Response to Comments

City of Lewiston Wastewater Facility

NPDES Permit Number: ID0022055

December 9, 2015

Maps

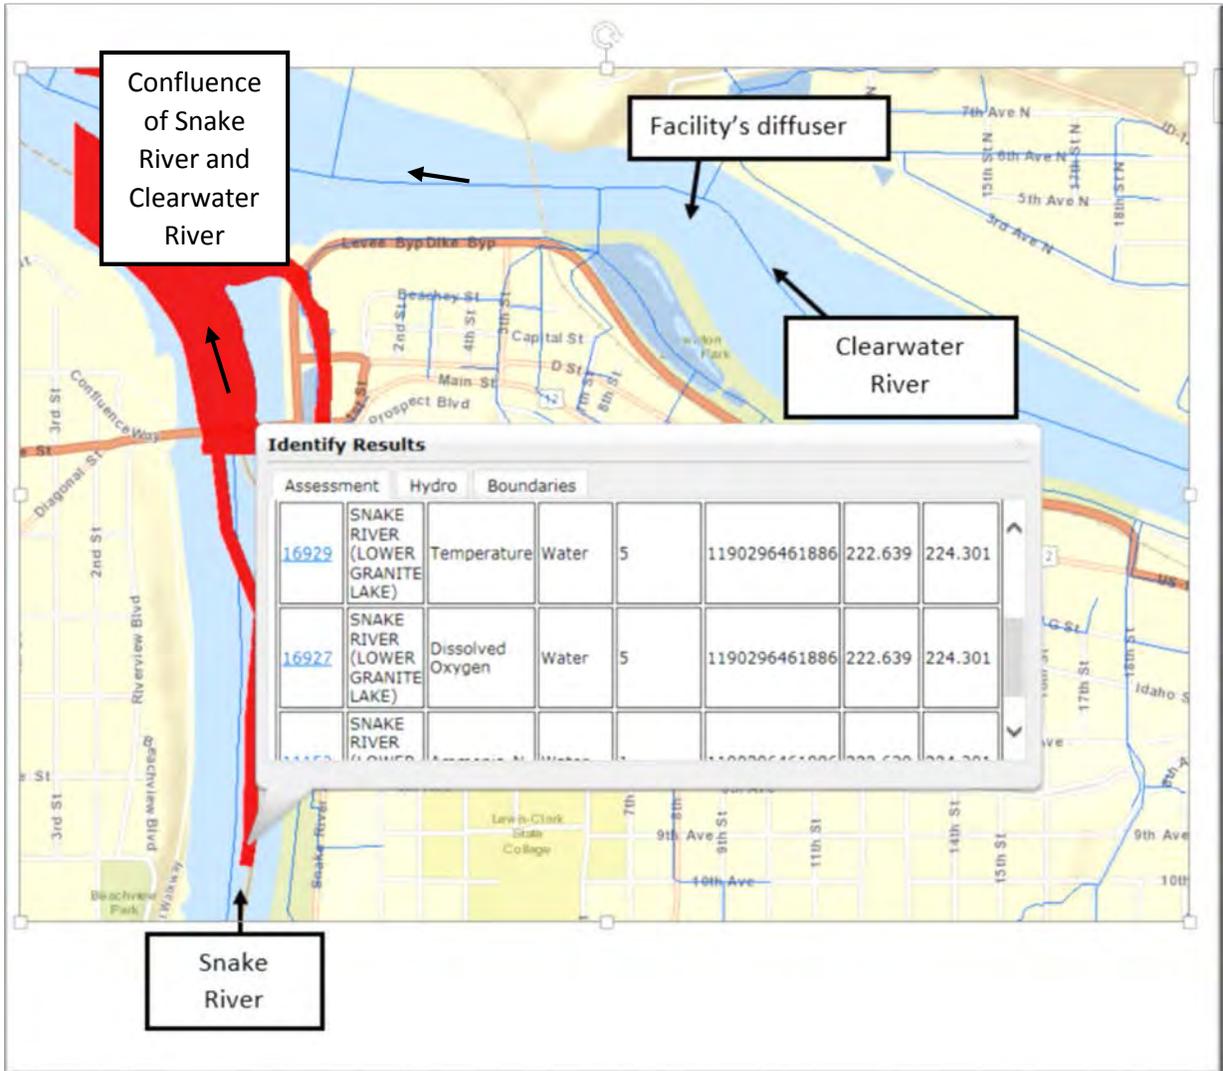
- The estimated total phosphorus loading from the Facility to the Snake River at the WA-ID state boundary is small, estimated at 1.16% of total loading on average (see calculations below).
- The nearest phosphorus listing in WRIA 33 is 131 miles downstream from the Facility (Listing #6366). Within the long stretch of the river, below the Facility to the

Phosphorus Listing #6366, is located approximately 131 miles downstream.

EPA used Washington State’s mapper tool for identifying possible nutrient impaired waters in the state. The mapper tool which is found at: <https://fortress.wa.gov/ecy/wqamapviewer/default.aspx?res=1280x1024> does not show a phosphorus listing in the vicinity downstream of the discharge in WRIA 35. Because dissolved oxygen (DO) impairments can be correlated with algae growth as a surrogate indicator to nutrients such as phosphorus, EPA identified areas of “Category 5” DO impairments as possible nutrient impairments in this case. There are (3) “Category 5” listings for DO in WRIA 35 – one listing is upstream (#16927), and two listings are downstream (#16906 and #16903). Listing #16927 is upstream in the Snake River. Listing #16906 is approximately 21 miles downstream on the Snake River, and Listing #16903 is further, approximately 29 miles downstream.

Listing #16906 is located 21 miles downstream.

There is a “Category 5” temperature listing in the Snake River immediately upstream of the confluence of the Snake/Clearwater Rivers (Listing #16929).
